14. Foundation Work - PENDING Denver Mint Job

Denver, Mint Addition,
Denver, Colo.
Nov. 5 th- 1935

Denver, Colo.
Oct. 26 th. 1935

Test Hole No 3 - U.S. Mint, Denver, Colo.

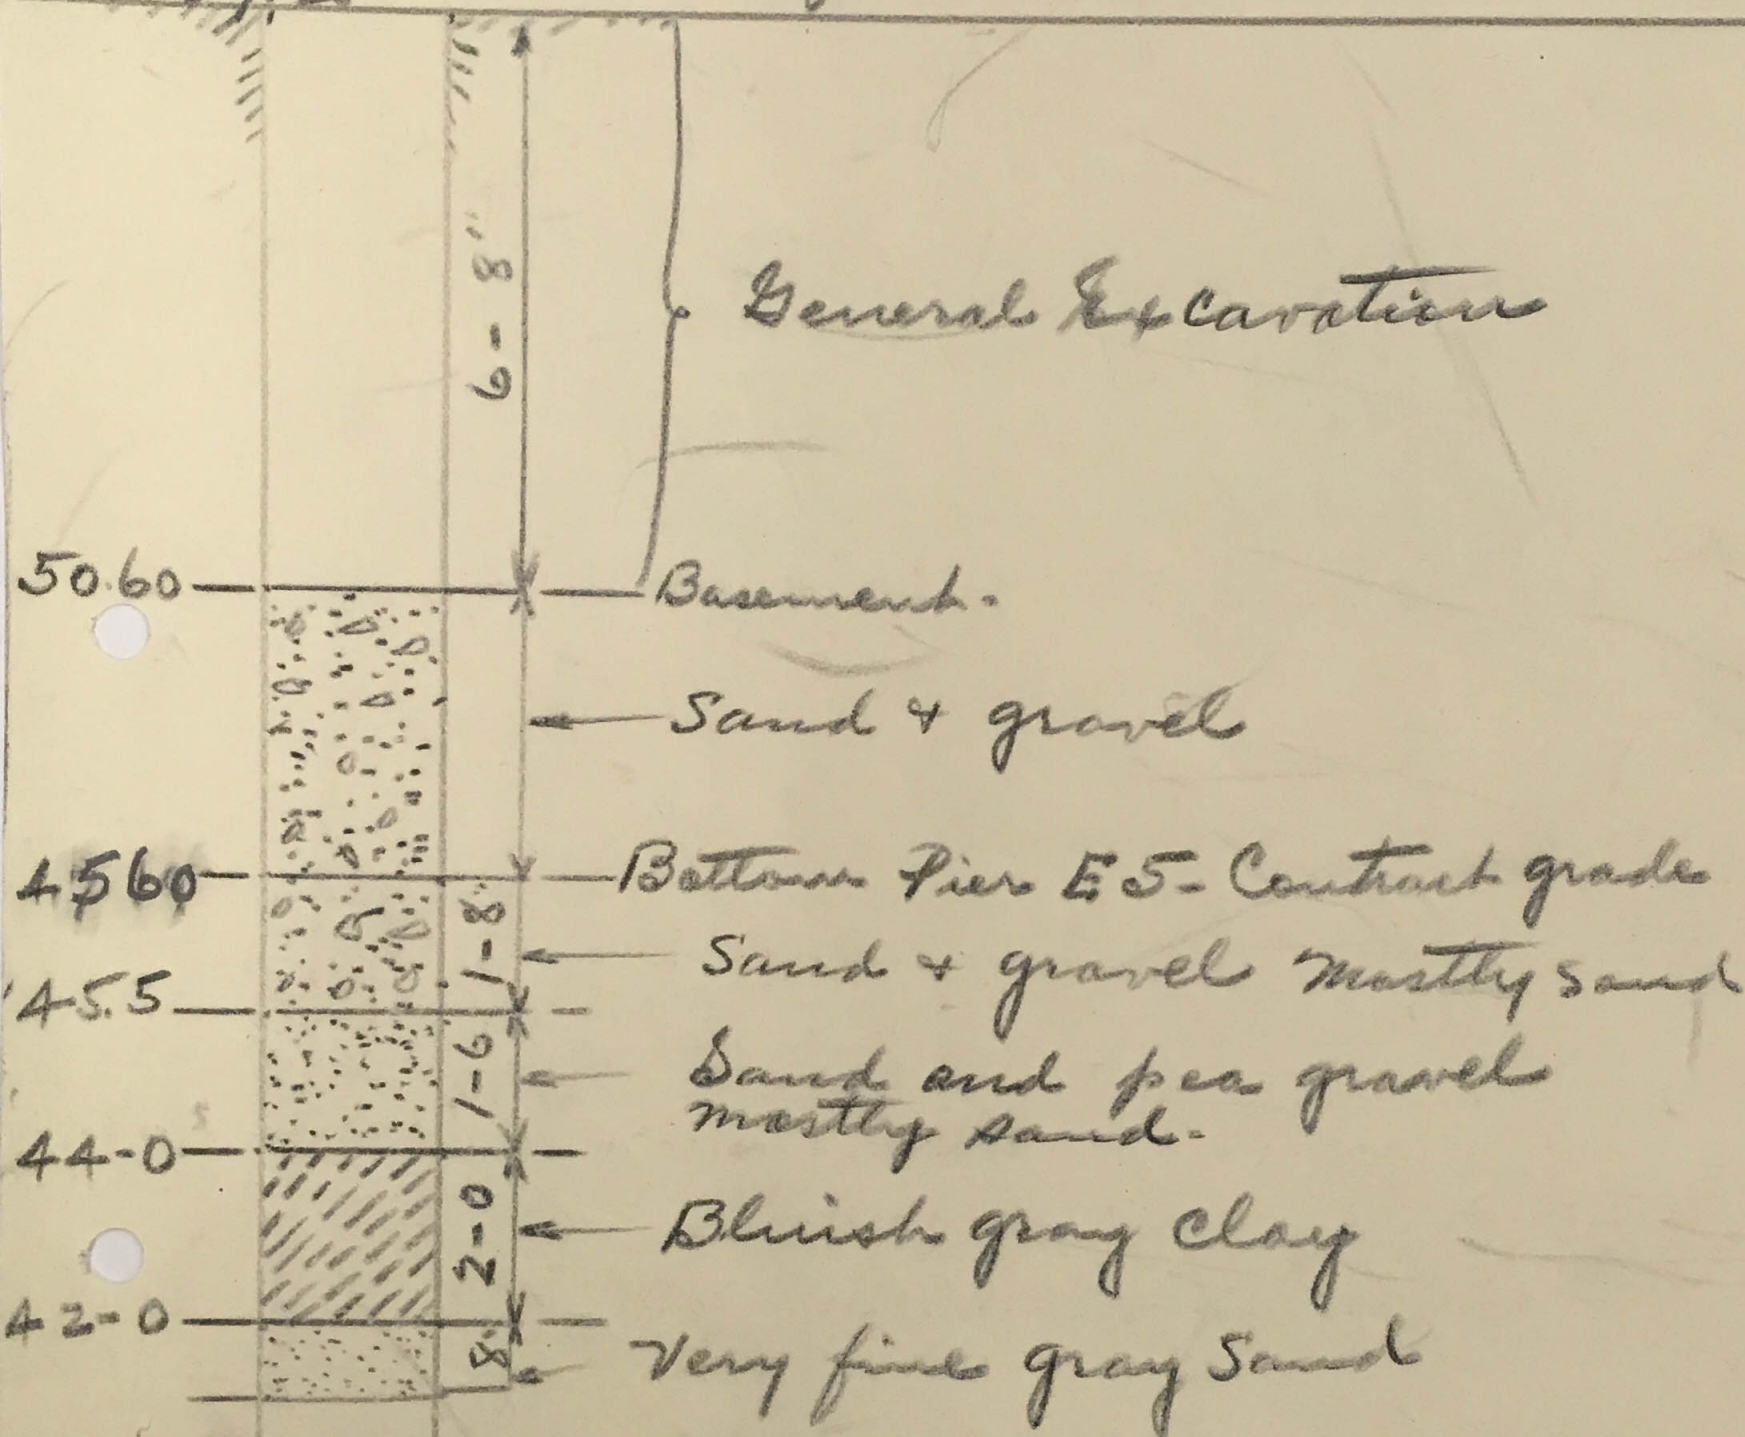
However, in the N.W. corner, under piers E-12- E-13 and under the inside row of Cols. running East along E-14 -E-5 -E19- there appears a layer of clay 2-0 to 2-3" thick that is not suitable for bearing up to 5,000 lbs. to the square foot.

Due to the designed load on the piers and the vibration that will be set up in the addition from the rolls and punching machines, I recommend that piers E-11- E-12 - E13- 14- E5 -E-19 and E-6 & E-7 be

YOU AUTHORIZED HAVE CONTRACTOR PROCEED LOWER FOOTINGS AS NECESSARY TO
REACH SUITABLE MATERIAL AT COST PLUS TEN AND TEN TOTAL
NOT TO EXCEED ESTIMATE ONE THOUSAND DOLLARS AS ADDITION HIS
CONTRACT PERIOD FOOTINGS TO REMAIN AS DESIGNATED AND INCREASED HEIGHT
EFFECTED BY PEDESTALS HAVING DIMENSIONS ONE FOOT GREATER EACH WAY
HAN STEEL FILLET SUPPORT

Test Hole # 8- U.S. Mint, Denver Colo.

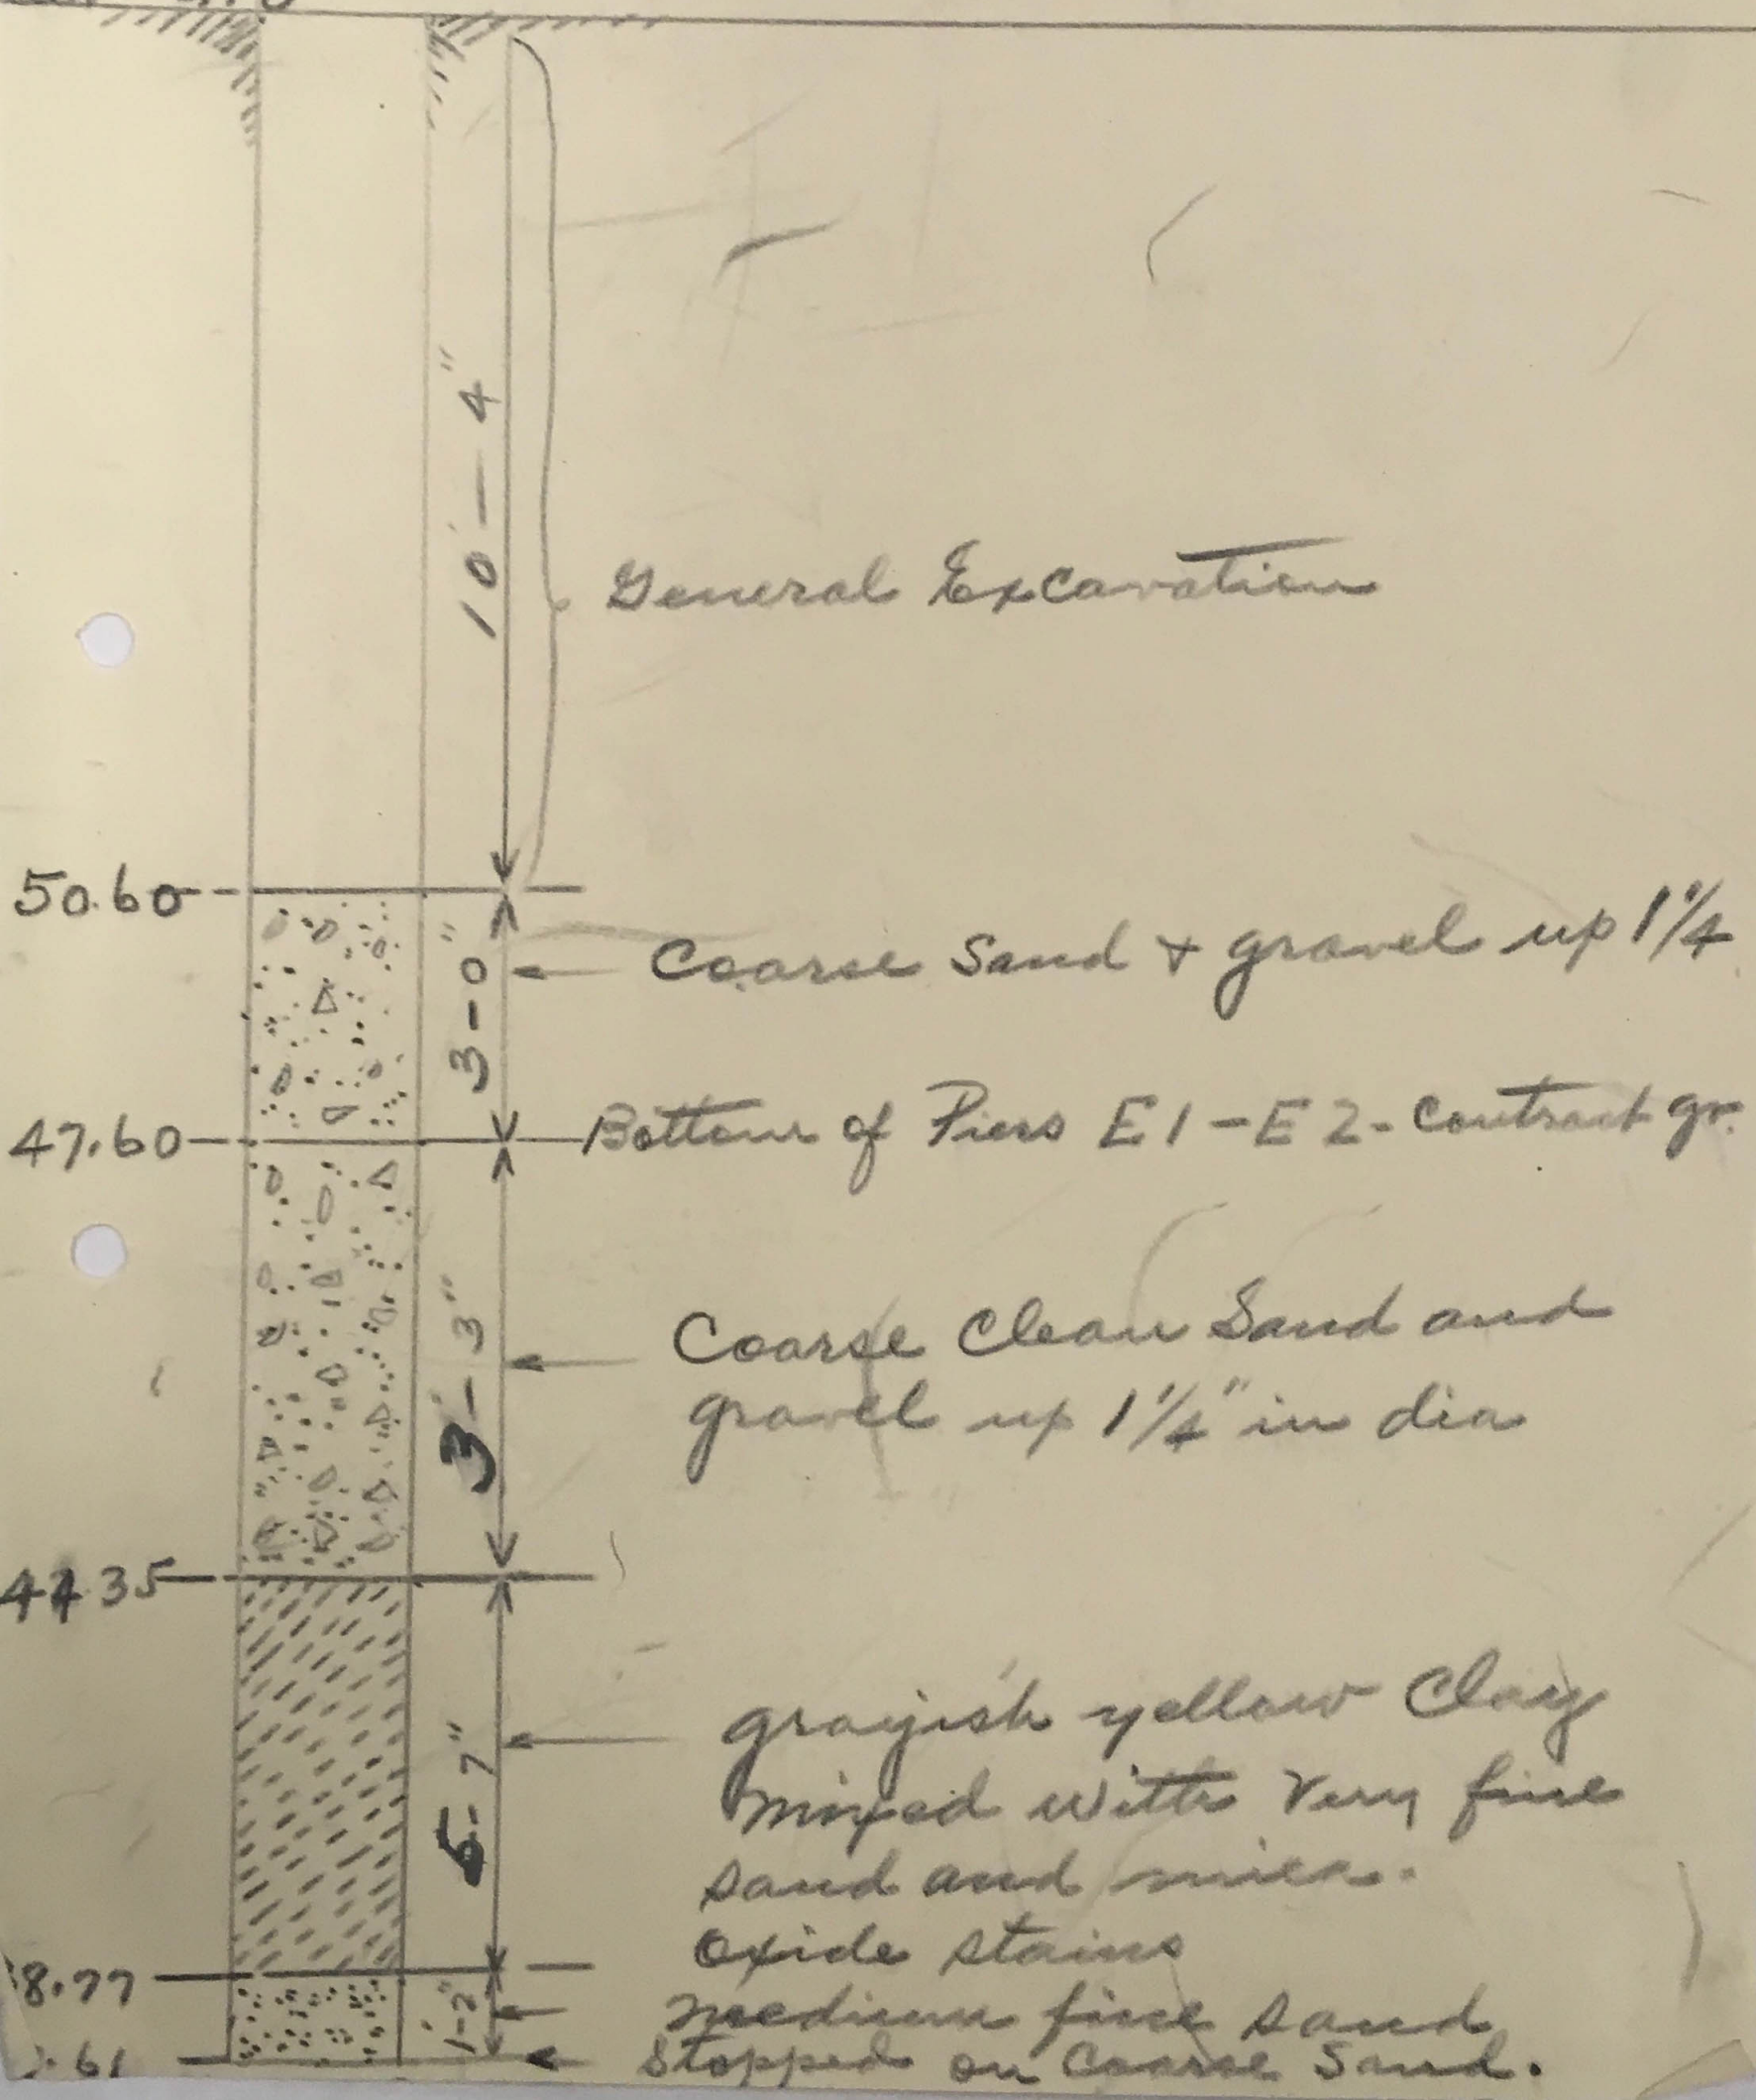
In the So.East corner under piers E-1 and E-2 the clay formation appeared 5-7" deep. However, these footing are higher up and we have a good coarse sand and gravel layer of 3-3" deep over the clay.

The matter of lowering piers E-1-~~4~~ E-2 and E-10 will be held at contract grade pending your further instructions.

YOUR WIRE 5TH. DENVER COLORADO MINT AUTHORITY WIRED
OCTOBER 25TH COVERED ALL FOOTINGS NECESSARY TO BE LOWERED TO SECURE
SATISFACTORY BEARINGS.

Test hole No-9- Mint Addition
Hole located Center Denver, Colo-
pier E-4.

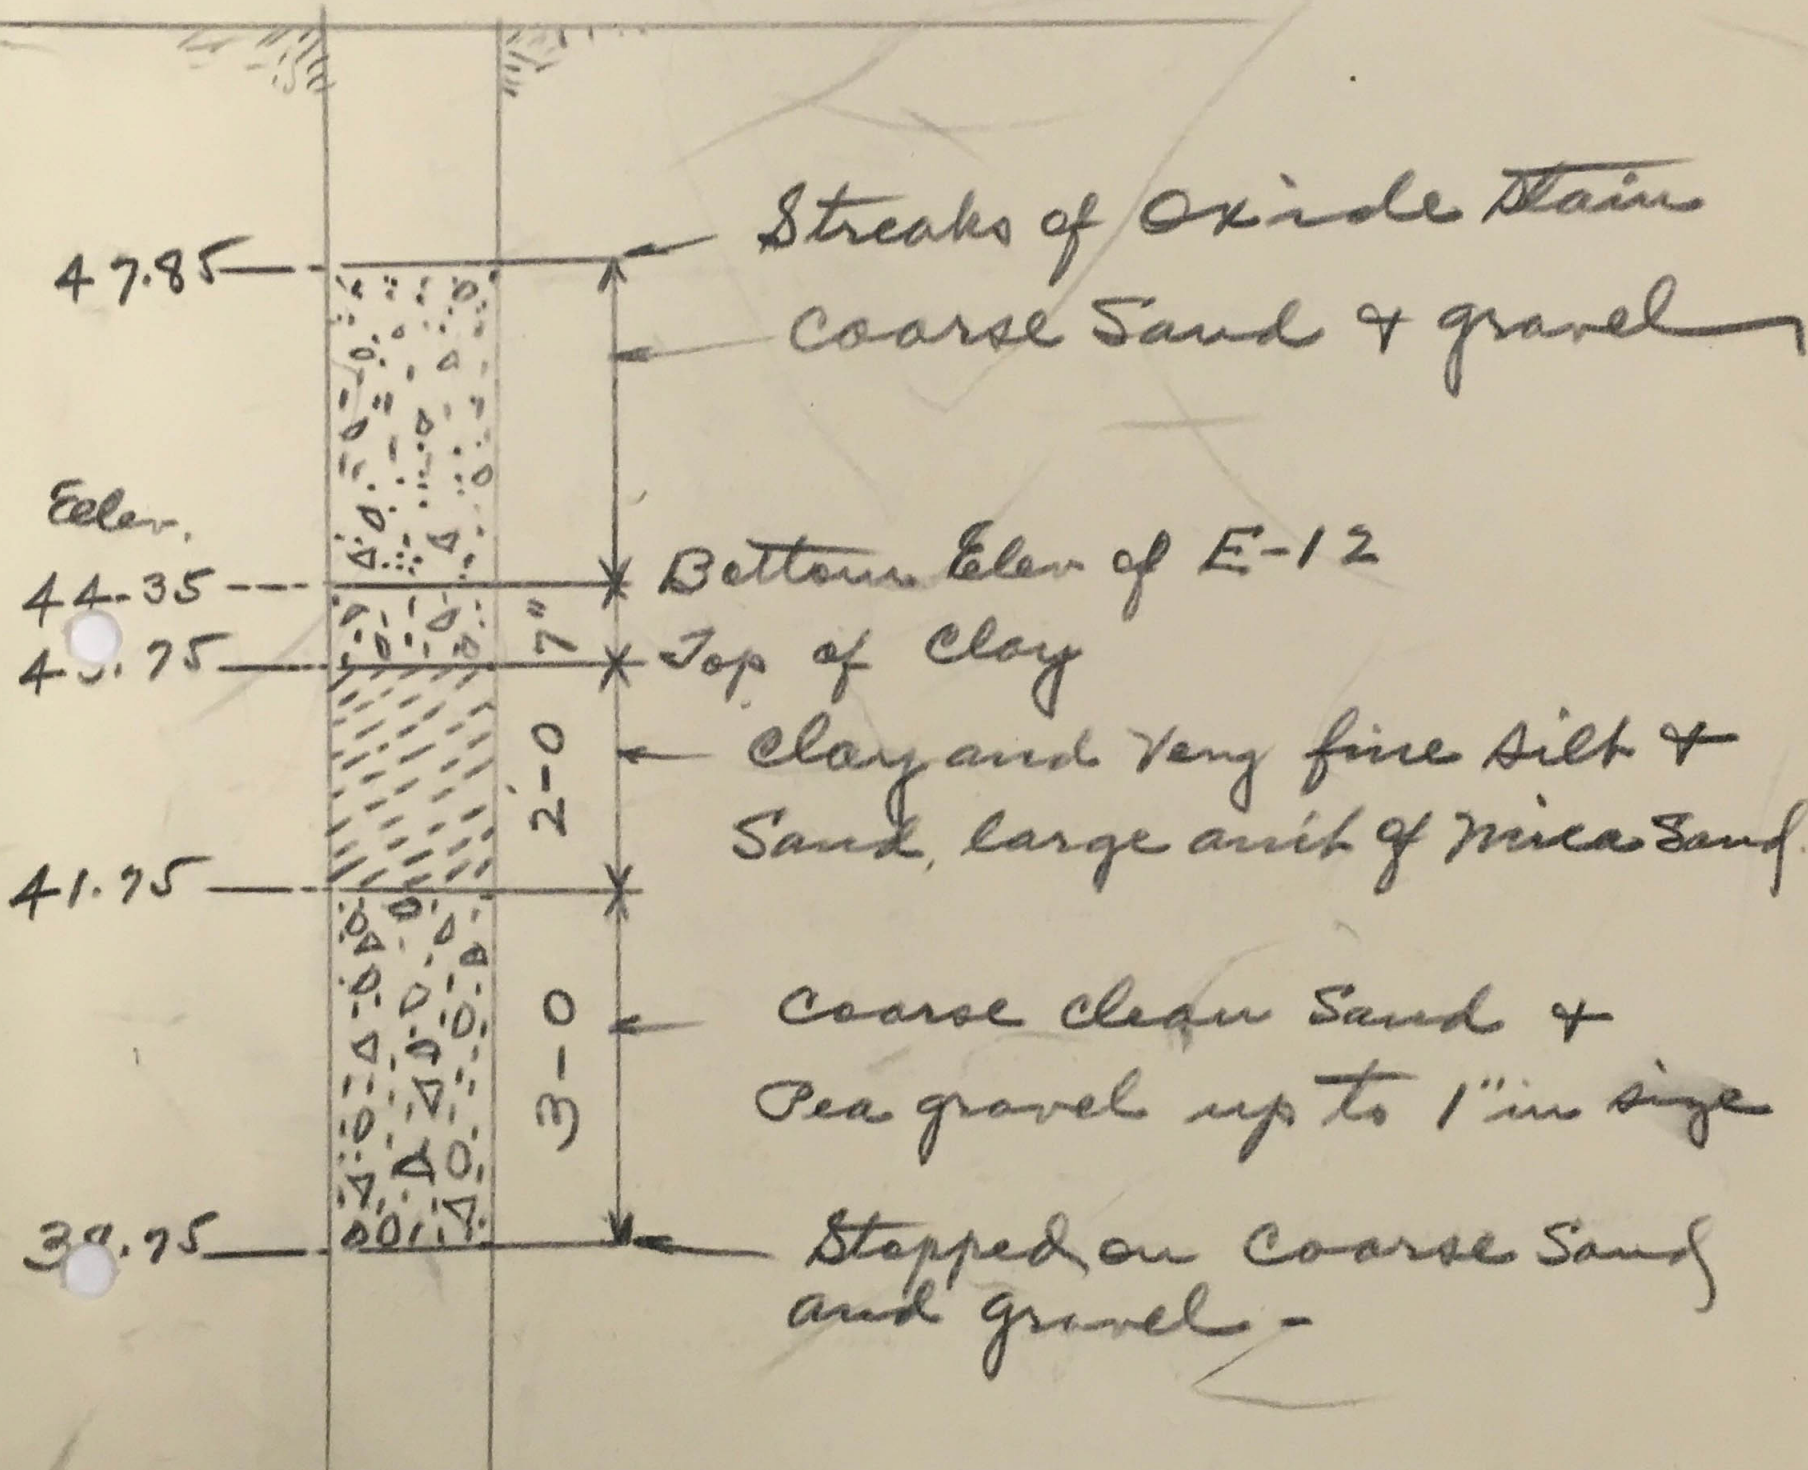
Formation about the same
as test hole # 5 under pier
E-3-
